IEEE 802.11
Wireless Access Method and Physical Layer Specifications

Title: Proposed Revisions to Section 7.1, 7.2, and 7.3 of
P802.11/D1.1

Abstract: This paper presents the changes to section 7.1, 7.2, and 7.3 to address a large number of letter ballot comments..

Action: Adopt the changes in this paper to replace the relevent portions of Section 7.1, 7.2, and 7.3 of P802.11/D1.1.

Figure 7-2 — Beacon transmission in an Ad Hoc network.

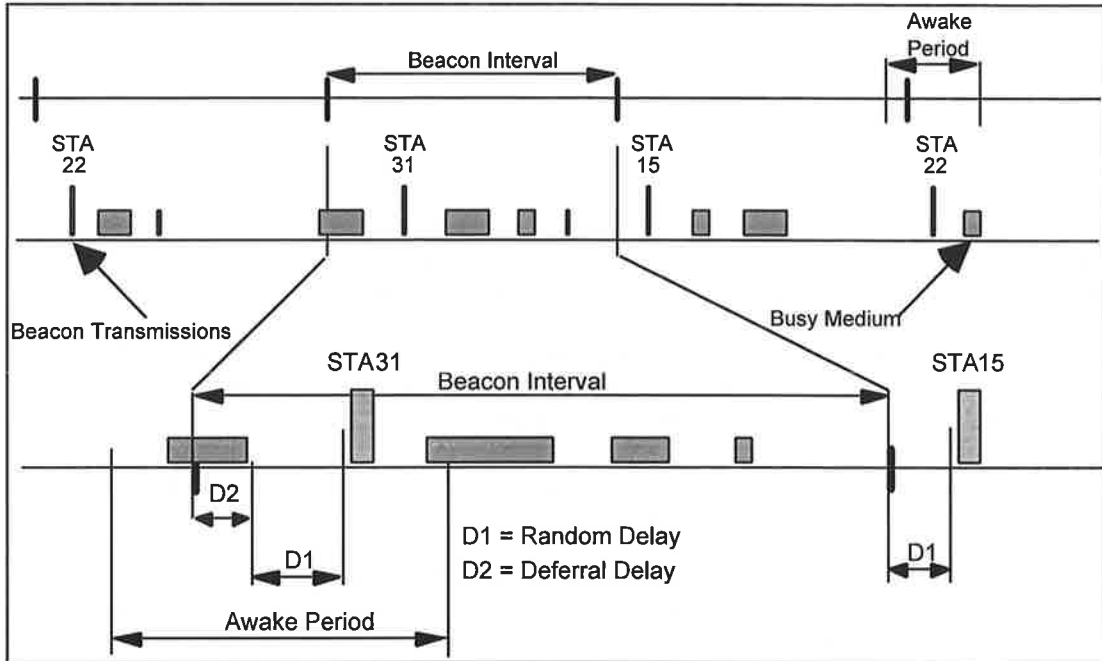
Beacon generation in an ad hoc network is distributed. All members of the BSS participate in Beacon generation. Each station shall maintain its own TSF timer which is used for aBeacon_Interval timing. This defines a series of Target Beacon Transmission Times (TBTTs) exactly aBeacon_Interval time units apart, time zero is defined to be a TBTT. At each TBTT the station shall 1) ~~save the timestamp from the most recently received Beacon,~~ 2) calculate a random delay, 3) wait for the period of the random delay, 4) if no Beacon has arrived during the delay period, send a Beacon, ~~go to step 1, otherwise~~ 5) go to step 2. See Figure 7-2.

Figure 7-5: Infrastructure Power Management Operation (No PCF Operating)

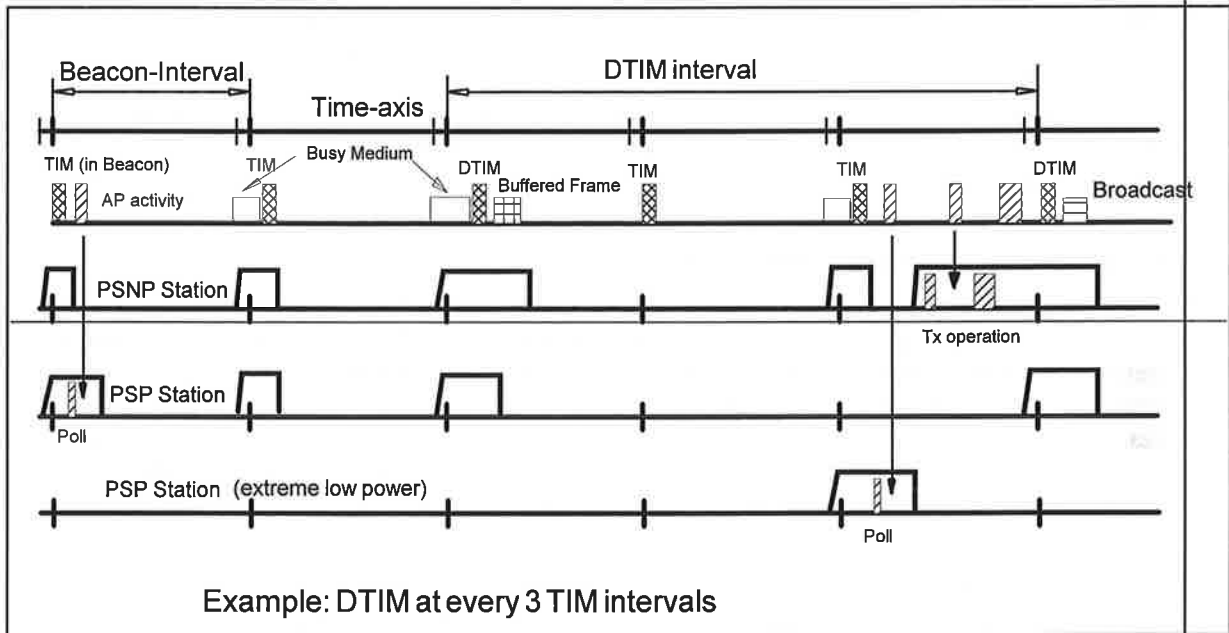
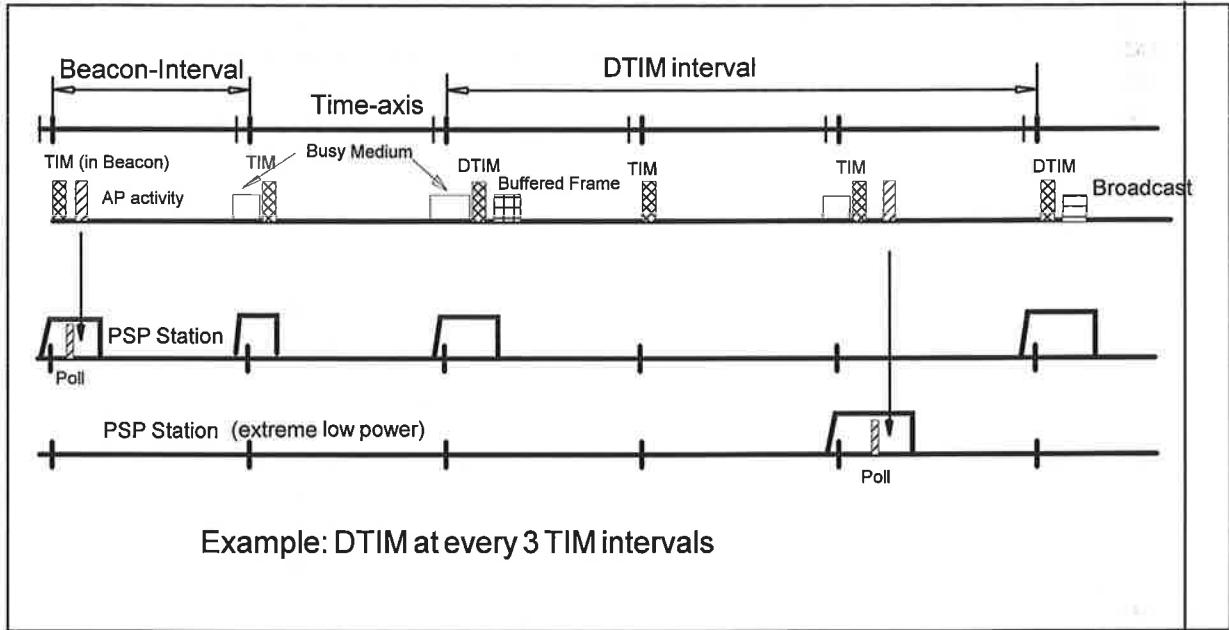
Two different TIM types are distinguished: ~~(ordinary) TIM, and DTIM, which stands for Delivery TIM. Immediately a~~ After a DTIM, the AP shall send out the stored Broadcast/Multicast frames using normal frame transmission rules, and all the frames stored (only those announced in the DTIM) for stations operating in the PSNP mode.

The AP shall transmit TIMs with every Beacon. Every ~~a~~ MACMGT_DTIM_Interval, a TIM of type "DTIM" is transmitted within a Beacon rather than an ordinary TIM.

The following figure illustrates the AP and station activity under the assumption that a DTIM is transmitted once every three TIMs.

Figure 7-6: Ad Hoc Power Management - Basic Operation

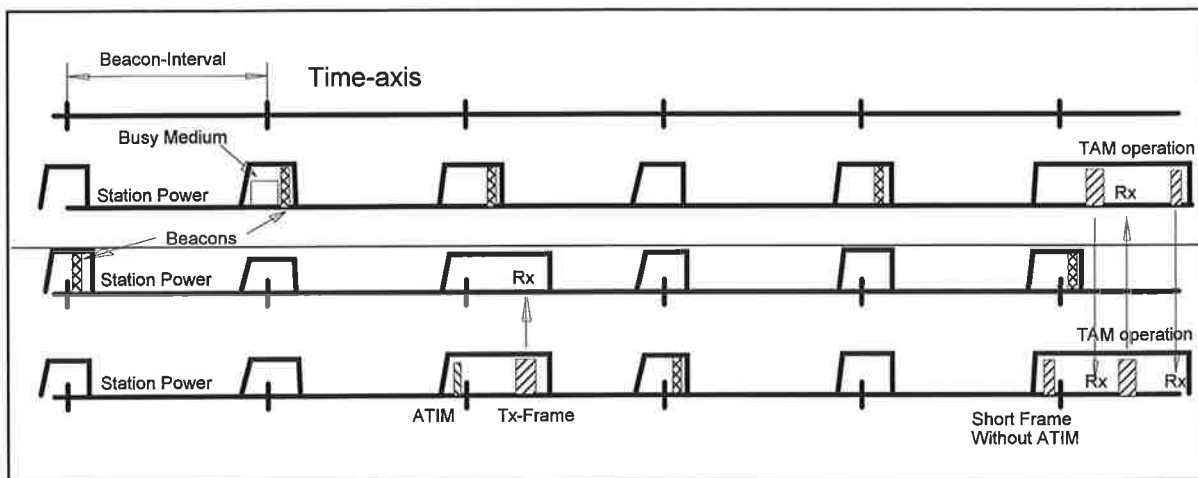
- a) The transceiver shall change to the "Awake" state at a predetermined "wake-up_window" time, triggered by the Beacon-Interval timer.
- b) The transceiver shall stay in the "Awake" state for a predetermined interval, unless an ATIM frame addressed to this station (Station address or multicast) is received.
- c) If the station receives an ATIM frame, then the station shall remain in the Awake state until it receives a subsequent Data frame.

This is illustrated in the following figure.
